Access Compliance Report

Public Rights-of-Way

(Curb Ramps)

Intersection ID: 10020989	Main Street: BERE_ISLAND_DR	Cross Street: N/A	Location: SW
ADA ID: 75CF3C2D1EC3	Ramp Type: PerpDiag	Initial Pass/Fail: Pass	Overall Compliance: No
Codes/Mitigation Info/Possible Solution		Field Measurements/Component Compliance	
Severity Score: 0.25

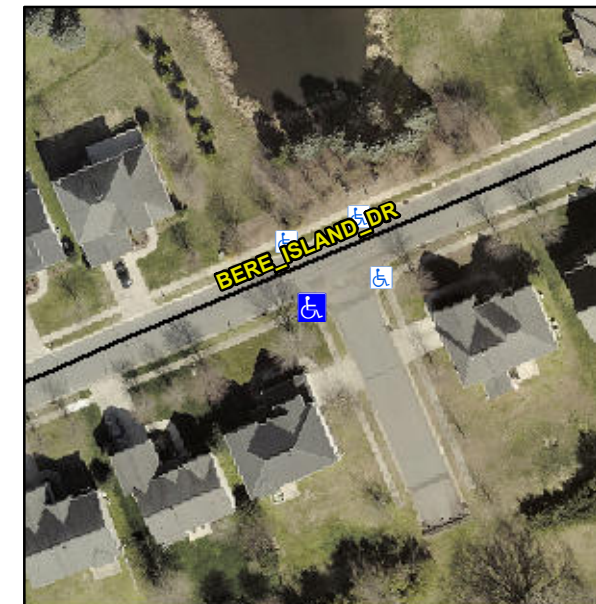
Not Found, R304.5.3, R304.2.1, R305.2

Compliance	Description	Data	Compliance	Description	Data
N/A	Ramp Length (in)	49.0	Yes	Ramp Slope (%)	5.9
Yes	Ramp Width (in)	48.0	No	Ramp XSlope (%)	2.1
N/A	Flare Type LT	Sloped	N/A	Flare Type RT	N/A
N/A	Flare Slope LT (%)	7.0	Yes	Flare Slope RT (%)	4.4
N/A	Flare Traversable LT?	Yes	N/A	Flare Traversable RT?	Yes
No	Landing Length (in)	47.0	Yes	DWS Provided?	Yes
Yes	Landing Width (in)	48.0	Yes	DWS Contrast?	Yes
Yes	Landing Slope (%)	0.8	Yes	DWS Length (in)	24.0
Yes	Landing X Slope (%)	0.5	Yes	DWS Full Width?	Yes
N/A	Landing Curb? (Y/N)	No	No	DWS Offset (in)	N/A
N/A	Shared Landing?	No			
Yes	Gutter Ponding?	No	Yes	Gutter Slope (%)	0.1
Yes	Gutter Lip Ht (in)	0.0	Yes	Gutter X Slope (%)	1.0
N/A	Painted X Walk1?	No	N/A	Painted X Walk2?	No
	X Walk 1 Direction	To NE		X Walk 2 Direction	To NW
N/A	X Walk 1 Width (in)	N/A	N/A	X Walk 2 Width (in)	N/A
	X Walk 1 Slope (%)	0.6		X Walk 2 Slope (%)	0.5
	X Walk 1 X Slope (%)	1.6		X Walk 2 X Slope (%)	1.2

Remove & Replace Curb Ramp With Two New Directional Ramps or Equivalent.
